Re: Stoughton City Landfill--Operation and Maintenance Plan

Operation and Maintenance Plan
Stoughton City Landfill
June 1999 Roy F. Weston Document
Comments and Modifications

SUBJECT: Comments on the Stoughton Operation and Maintenance Plan

**OPERATION AND MAINTENANCE PLAN
STOUGHTON CITY LANDFILL
STOUGHTON, WISCONSIN**

FIGURE 1-1

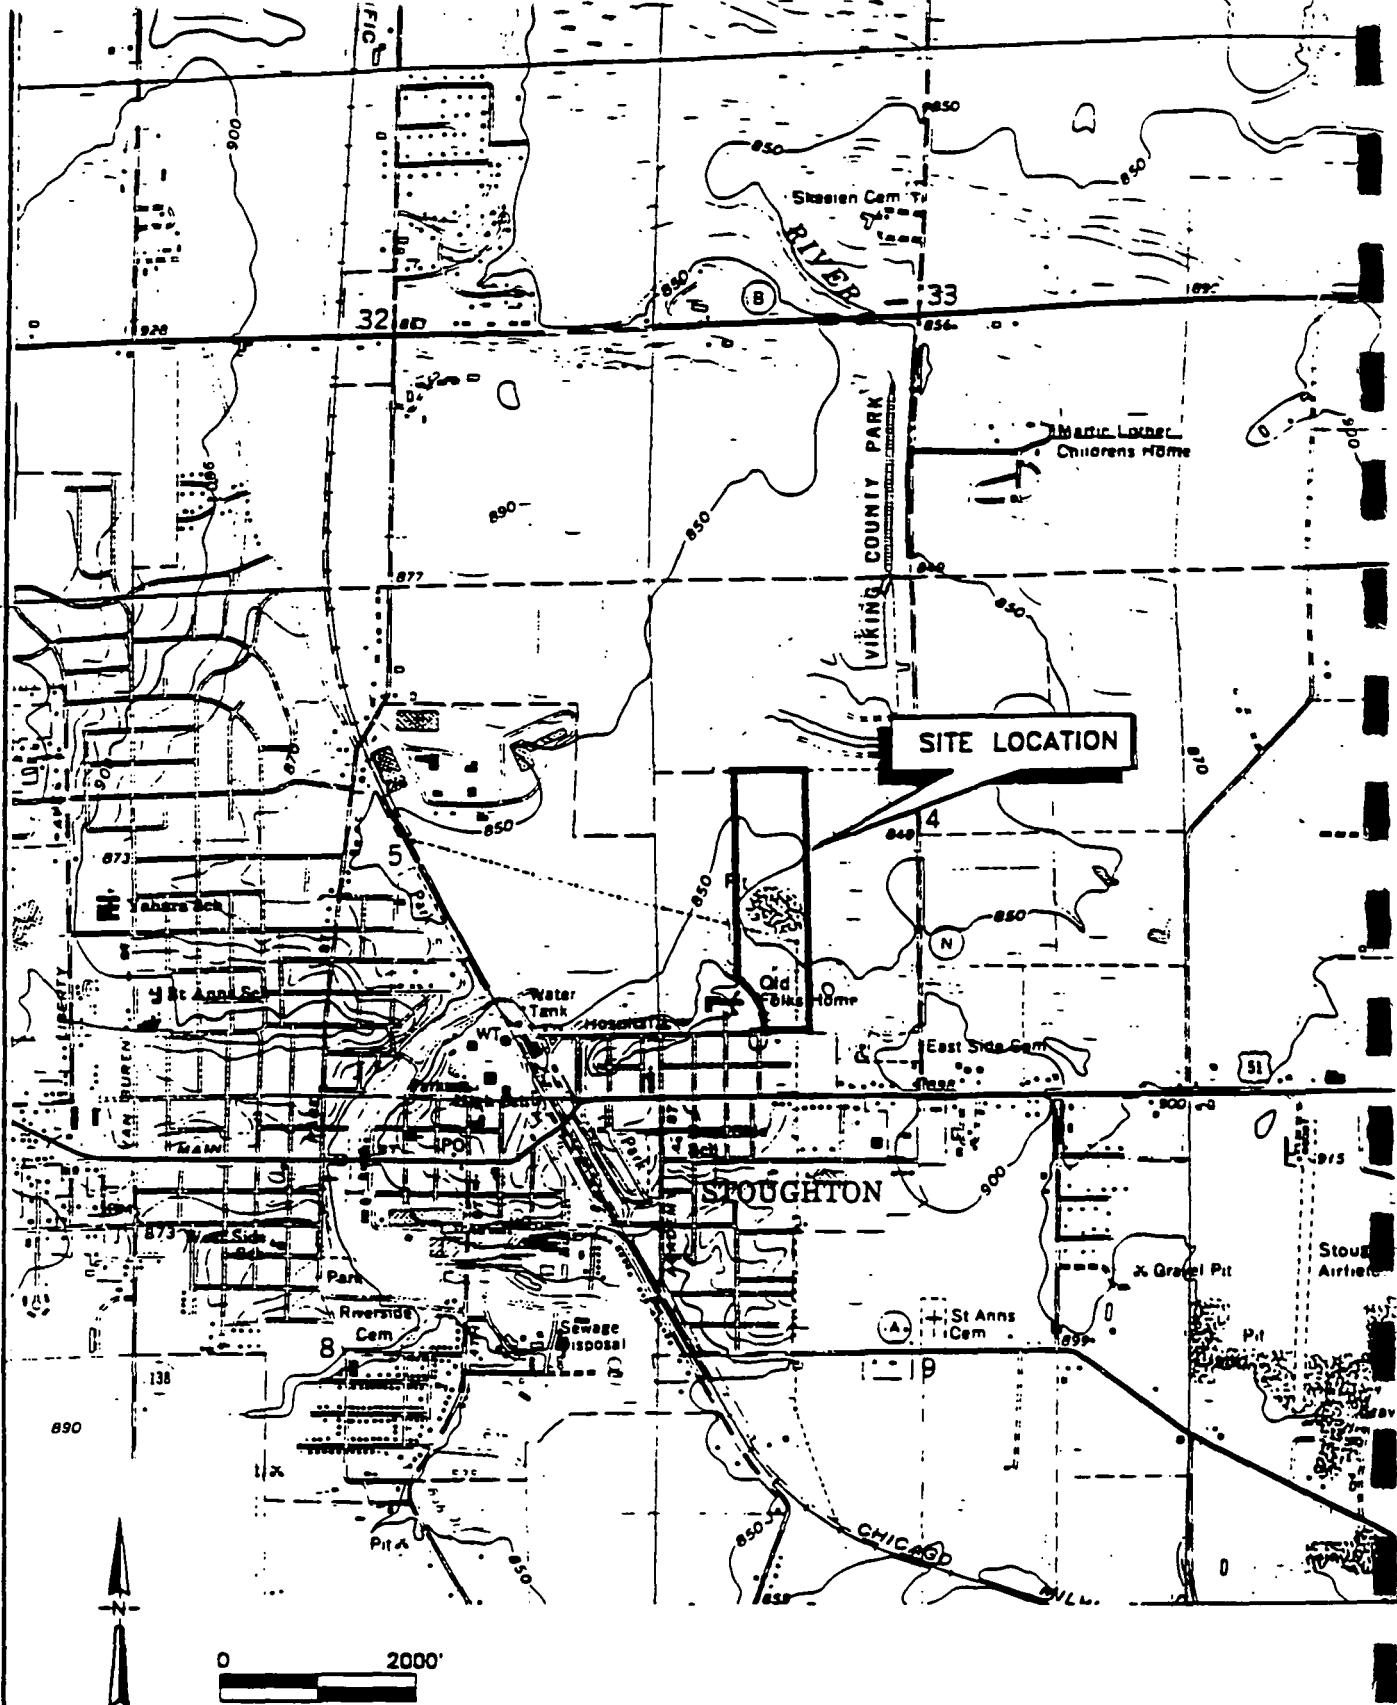
Figure 1-1. Apparently the site does not occupy the entire area indicated as the site location. Based on the stated size of the site (27 acres) and some figures in other documents, the site probably extends from the north boundary of this area down to approximately the dotted line that extends across it (which is probably the overhead electrical lines), and occupies the full width of the area.

It is unfortunate that the Yahara River does not show on the map near the site.
